PDPLANPMTD-2023/041144

PROPOSAL: Demolition of Existing Dwelling & Two New Multiple Dwellings

LOCATION: 11 Sunnyside Road, Lindisfarne

PLANNING APPLICATION - PDPLANPMTD-2023/041144 - 11 Sunnyside Road, Lindisfarne

FRONT FENCE ELEVATION

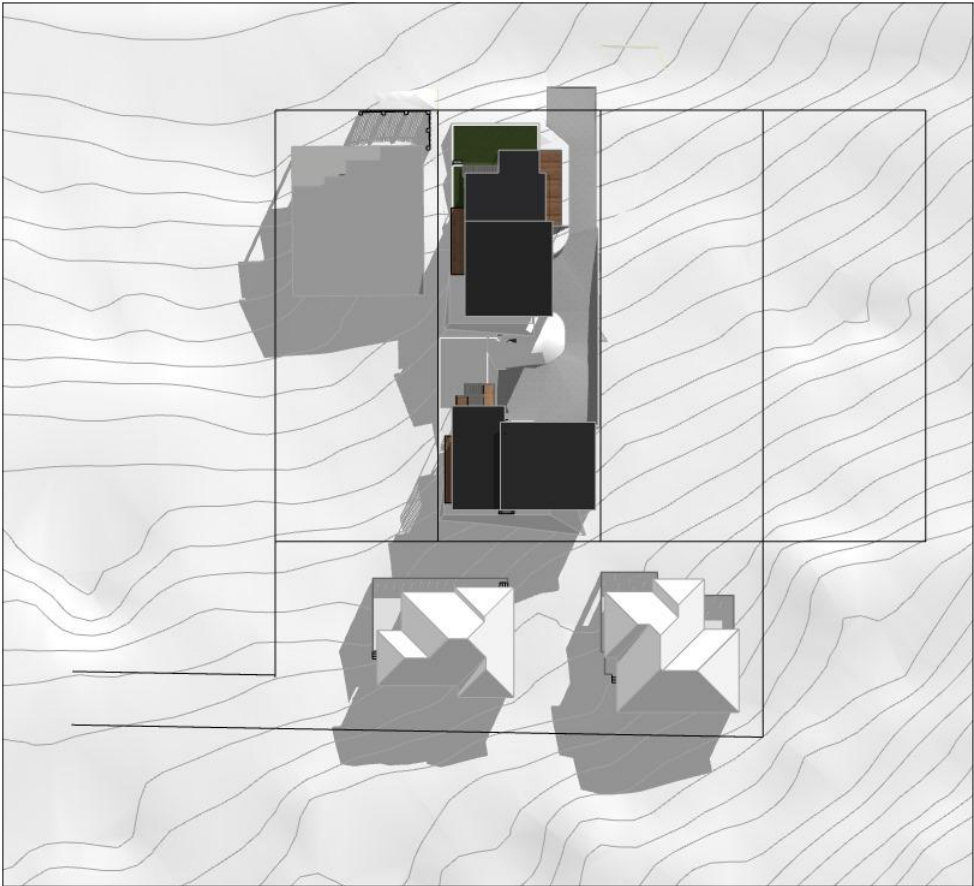
7	<p>8.4.7 FRONTAGE FENCES FOR ALL DWELLINGS</p> <ul style="list-style-type: none"> • Provide documentation addressing the performance criteria, P1, for this clause. 	The front boundary wall consists of a terraced retaining wall not higher than 1m and will be provided with landscaping to soften the appearance of the walls. 5 Sunnyside Road consists of a solid wall to 1.8m max height and our proposed wall will be used for a terraced garden as opposed to a front fence.
8	<p>8.4.8 WASTE STORAGE FOR MULTIPLE DWELLINGS A1 or P1.</p> <ul style="list-style-type: none"> • Provide documentation meeting the acceptable solution for this clause, alternative provide documentation addressing the performance criteria, P1, for this clause. 	See Landscaping Plan for more information.
9	<p>C2.5.1 CAR PARKING NUMBERS</p> <ul style="list-style-type: none"> • Seven parking spaces are required to meet the acceptable solution for this clause. Please amend the plans to meet the acceptable solutions, A1, or provide documentation addressing the corresponding performance criteria, P1, for this clause. 	N/A see above Item 1 statement.

Building Envelope

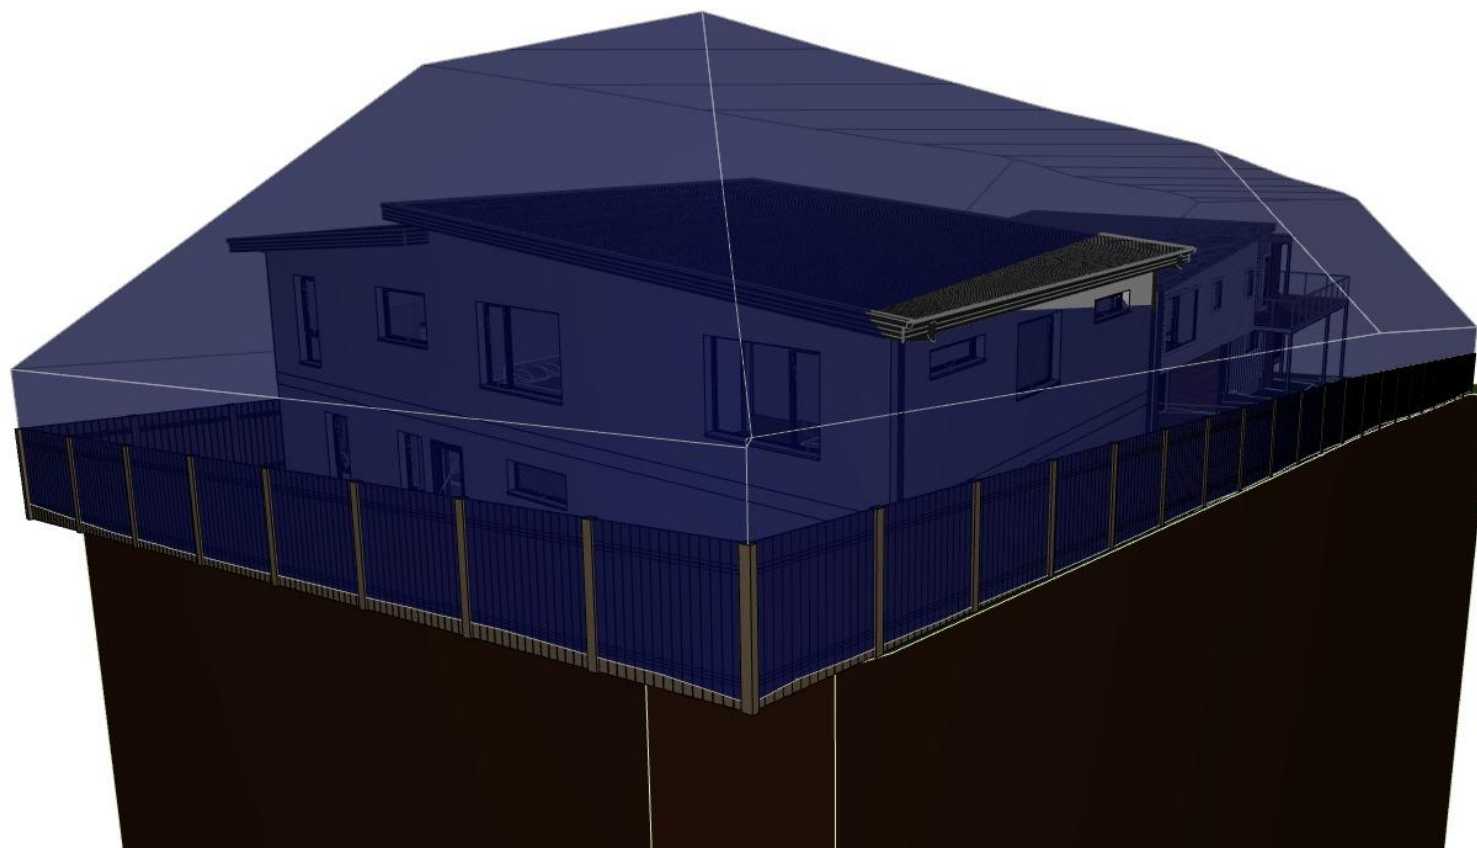
3	8.4.2 SETBACKS AND BUILDING ENVELOPES FOR ALL DWELLINGS P1 • Provide documentation addressing the performance criteria, P1, for this clause, in relation to the retaining wall within 4.5m of the frontage.	The front boundary wall consists of a terraced retaining wall not higher than 1m and will be provided with landscaping to soften the appearance of the walls. 5 Sunnyside Road consists of a solid wall to 1.8m max height and our proposed wall will be used for a terraced garden as opposed to a front fence.
4	8.4.3 SITE COVERAGE AND PRIVATE OPEN SPACE FOR ALL DWELLINGS A1 or P1, and A2 or P2 • Show Private Open Space of not less than 60m ² for each of the multiple dwellings (4) on the site plan. Alternatively provide documentation addressing the corresponding performance criteria, P1, for this clause.	N/A see above Item 1 statement.

Unit 1 & 2 are both slightly outside of the building envelope (see Building Envelope model for more information) Shadow diagrams have been provided to show the effects on neighbouring properties. Shadow diagrams show that neighbouring dwellings have minimal overshadowing on the POS and no reduction in sunlight to habitable rooms. Visual bulk is reduced by Unit 1 and 2 being cut in significantly at the rears of the building presenting more as a single storey. The units also have articulated facades utilizing different cladding types to prevent “blank” walls when presented to neighbours.
